# Access Compliance Report

## Public Rights-of-Way

Intersection ID: 10020667	Main Street: BEACON_VALLEY_ST	Cross Street: N/A	Location: S
ADA ID: D4341109B240	Ramp Type: Perp	Initial Pass/Fail: Fail	Overall Compliance: No
		Severity Score: 12.5

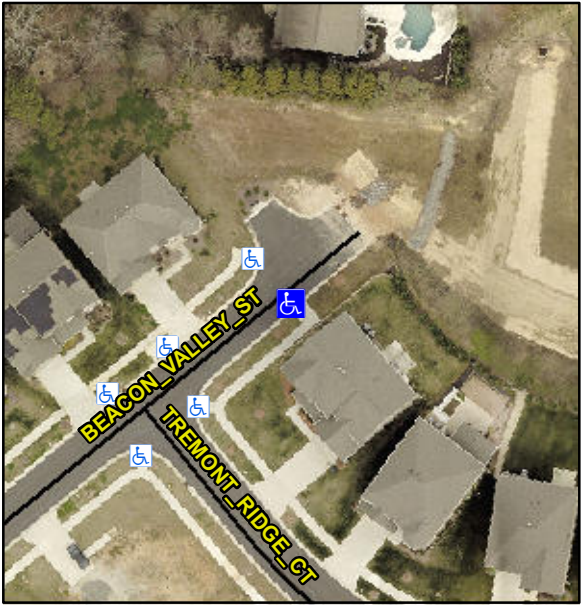
Codes/Mitigation Info/Possible Solution			Field Measurements/Component Compliance		
	Possible Solutions:		<b>Compliance</b>	<b>Description</b>	<b>Data</b>
	<b>Remove &amp; Replace Entire Ramp.</b>		<b>Yes</b>	Ramp Length (in)	93.0
			<b>No</b>	Ramp Width (in)	48.0
			<b>N/A</b>	Flare Type LT	N/A
			<b>N/A</b>	Flare Slope LT (%)	N/A
			<b>N/A</b>	Flare Traversable LT?	N/A
			<b>N/A</b>	Landing Length (in)	N/A
			<b>N/A</b>	Landing Width (in)	N/A
			<b>N/A</b>	Landing Slope (%)	N/A
			<b>N/A</b>	Landing X Slope (%)	N/A
<p>Surveyor Notes:</p> <p><b>N/A</b></p>			<b>N/A</b>	Landing Curb? (Y/N)	N/A
			<b>N/A</b>	Shared Landing?	N/A
			<b>N/A</b>	Gutter Ponding?	N/A
			<b>N/A</b>	Gutter Lip Ht (in)	N/A
			<b>No</b>	Painted X Walk1?	N/A
			<b>To NW</b>	X Walk 1 Direction	N/A
			<b>N/A</b>	X Walk 1 Width (in)	N/A
			<b>2.7</b>	X Walk 1 Slope (%)	N/A
			<b>6.5</b>	X Walk 1 X Slope (%)	N/A
			<b>N/A</b>	Ramp inside XWalk1?	N/A

<p>PROW/ADA:</p> <p><b>Not Found, R304.5.3</b></p>			<b>N/A</b>	Road Slope (%)	N/A
			<b>N/A</b>	Road X Slope (%)	N/A
			<b>N/A</b>	Any Obstructions?	N/A
				Obstruction Type	N/A
			<b>N/A</b>		N/A
			<b>Yes</b>	Surface Condition? (G/P)	Good
Total Cost:		\$ 1850.00
